<b>Topic</b>	Flying Spur - Front Seat Rail - Proximity Sensor Check (SC14/15)
<b>Market area</b>	United States E05 Bentley USA and rest America (6E05)
<b>Brand</b>	Bentley
<b>Transaction No.</b>	2037363/1
<b>Campaign number</b>	EA15
<b>Note</b>	EA15
<b>Type</b>	EA15
<b>US code</b>

### Flying Spur - United States and rest of America

### Technical background

Figure 1

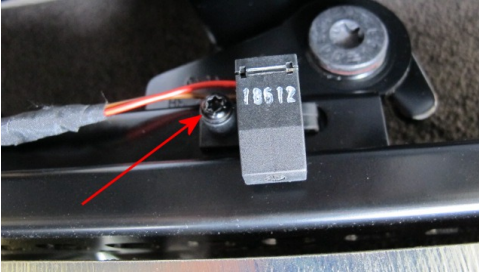
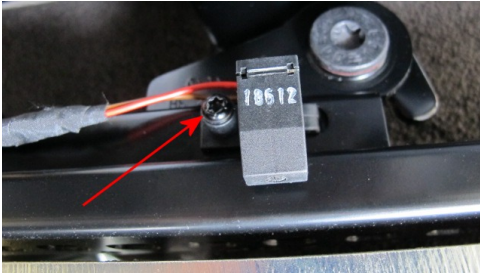
The front seat proximity sensors are located under both front seats at the front of the inner seat rail. The screw which secures the front right hand seat proximity sensor (Figure 1) and the screws which secure the left hand front proximity sensor and proximity sensor bracket (Figure 2) require replacing using a later specification part.

Figure 3

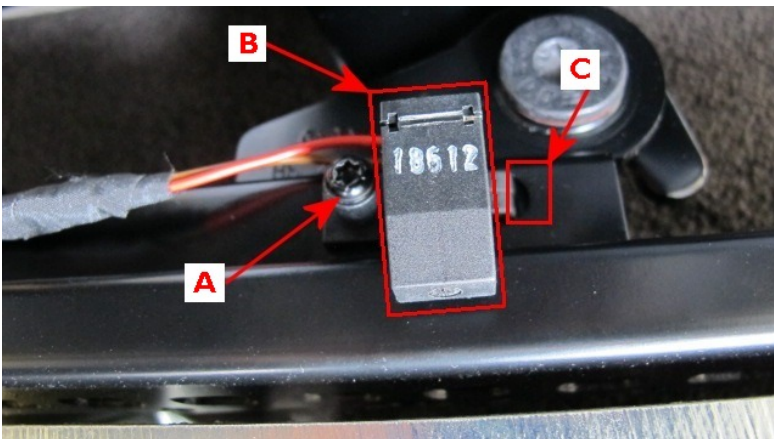
- Referring to Figure 3 - Point A - Change the proximity sensor screw using part number N907 321 03
- Point B - Confirm the overall condition of the sensor outer casing, the outer casing should be not cracked, damaged or distorted
  - Point C - Confirm the sensor locating tang is inserted into the seat frame

Figure 4

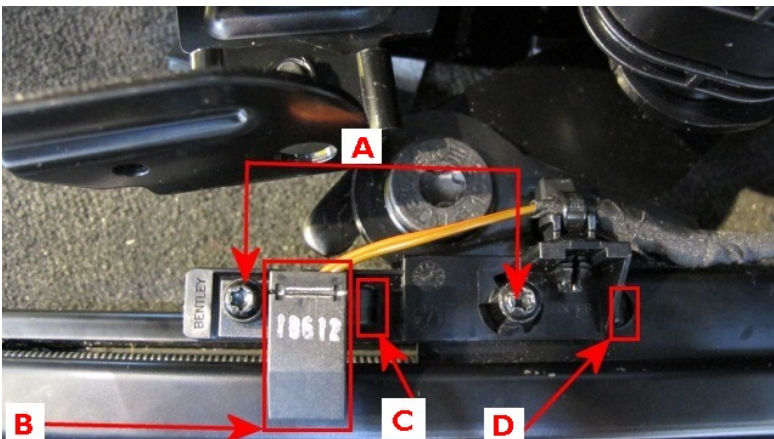
- Referring to Figure 4 - Point A - Change the proximity sensor screw and sensor bracket screw using part number N907 321 03
- Point B - Confirm the condition of the sensor outer casing, the outer casing should not be cracked damaged or distorted
- Point C - Confirm the sensor tang is located into the sensor bracket
- Point D - Confirm the sensor bracket tang is located into the seat frame

Figure 9

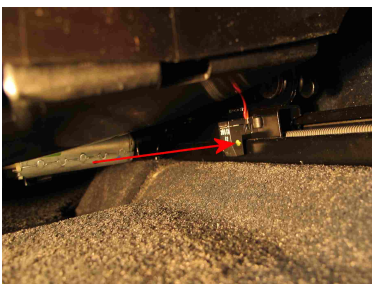
3. To confirm the following tasks (a to c) have been conducted or replaced as part of this procedure place a yellow confirmation mark on both proximity sensors as shown in Figure 9 (right) and 10 (left)

Figure 21

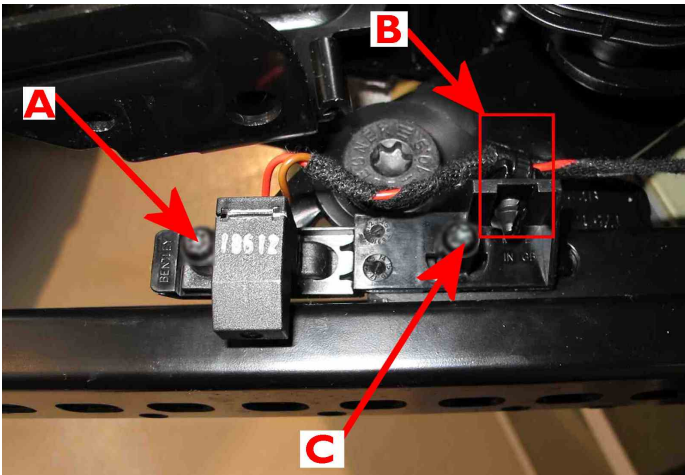
- Insulate both splices and loom using suitable insulation tape
- Referring to Figure 21 (Point A) – secure the sensor to the new bracket using a new screw with the part number N907 321 03
- Refit the original fir tree clip and secure the loom using a new cable tie (Point B)
- Locate the bracket tang and bracket location peg into the seat frame and secure the bracket to the seat frame using a new screw with the part number N907 321 03 (Point C)
